CITY OF UNLEY
COUNCIL ASSESSMENT PANEL

I write to advise of the Council Assessment Panel Meeting to be held on Tuesday 19 September 2023 at 6:00pm in the Unley Council Chambers, 181 Unley Road Unley.

Item No	Planning, Development Infrastructure Act Applications	Page
1.	3 Mitchell Street, Hyde Park – 23012676	4-30
2.	5 Glenferrie Avenue, Myrtle Bank - 21011428	31-335

ITEM 1**DEVELOPMENT APPLICATION - 23012676 – 3 MITCHELL STREET, HYDE PARK SA 5061**

Figure 7: Potential conflict for drivers turning right to the site and to Waite Road

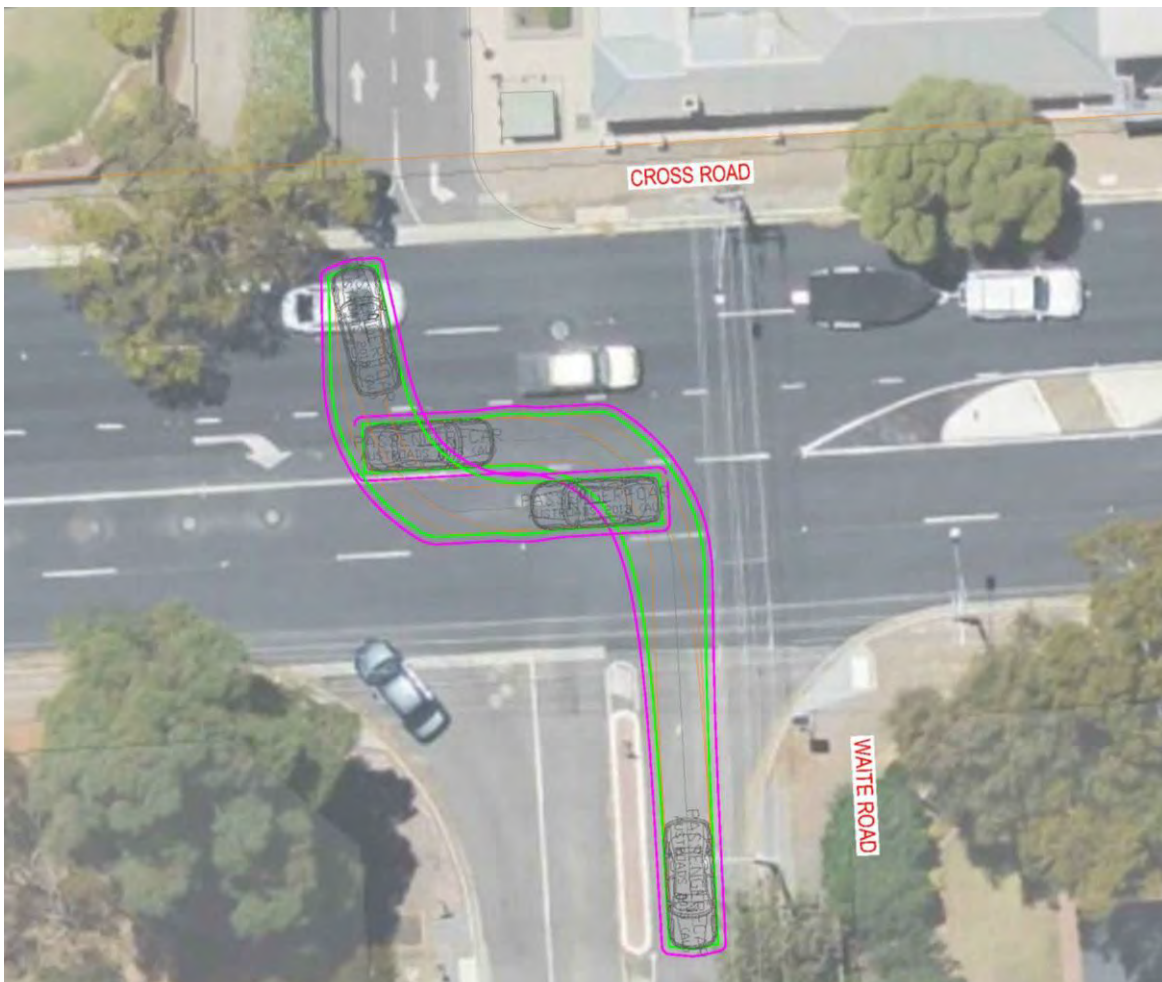
Adopting the above rate, the proposal would generate an additional 12 trips during peak traffic periods, resulting in a peak hour volume in the order of 31 trips. While this volume is not significant, the existing access is non-compliant and results in crash risks as a result of the access being in an undesirable location. The increase in volumes, therefore, increases this risk to pedestrians and drivers associated with the development and equally to drivers turning to Waite Road. Figure 7 illustrates the potential conflict between drivers turning right to the site and drivers turning to Waite Road.

Figure 7: Potential conflict for drivers turning right to the site and to Waite Road

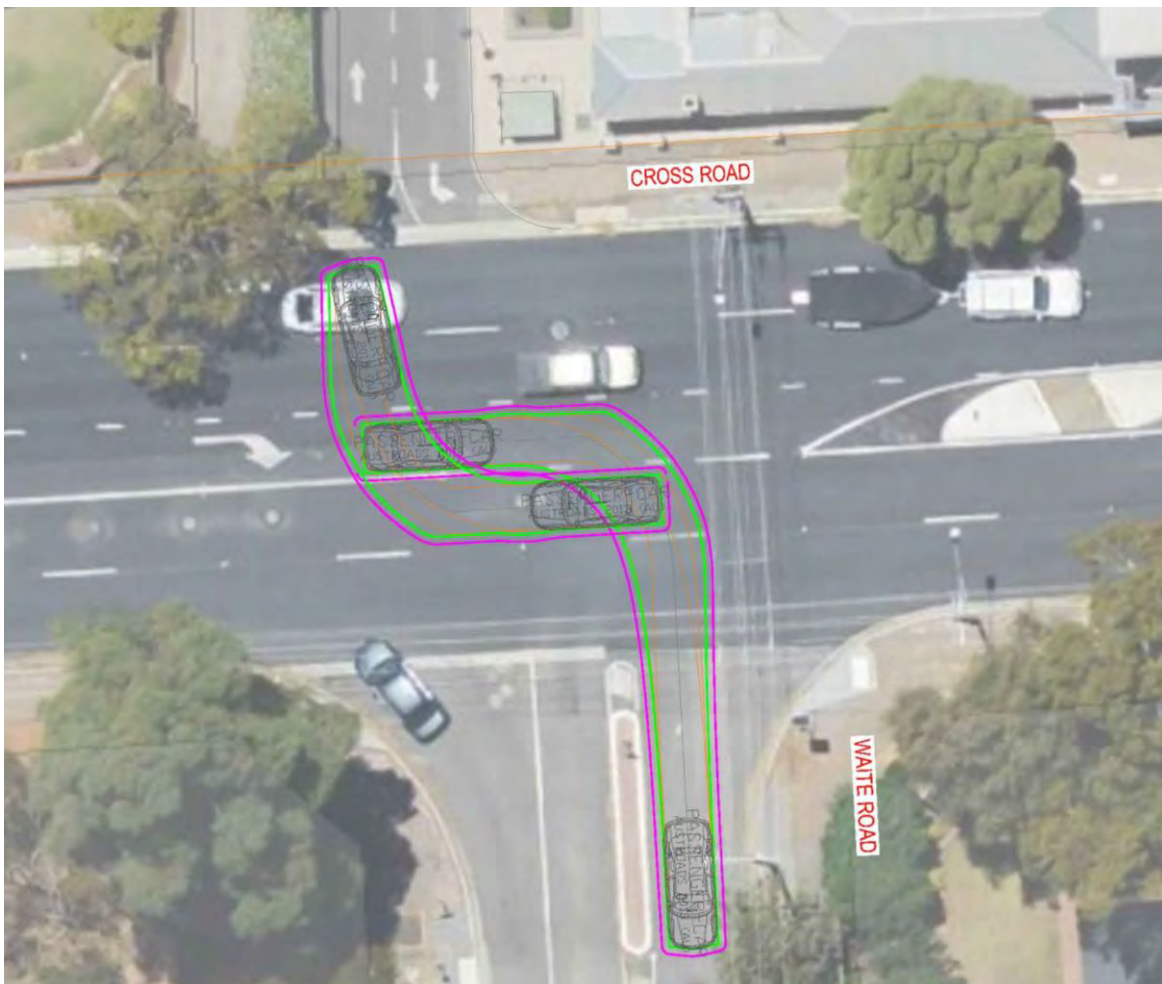
Adopting the above rate, the proposal would generate an additional 12 trips during peak traffic periods, resulting in a peak hour volume in the order of 31 trips. While this volume is not significant, the existing access is non-compliant and results in crash risks as a result of the access being in an undesirable location. The increase in volumes, therefore, increases this risk to pedestrians and drivers associated with the development and equally to drivers turning to Waite Road. Figure 7 illustrates the potential conflict between drivers turning right to the site and drivers turning to Waite Road.
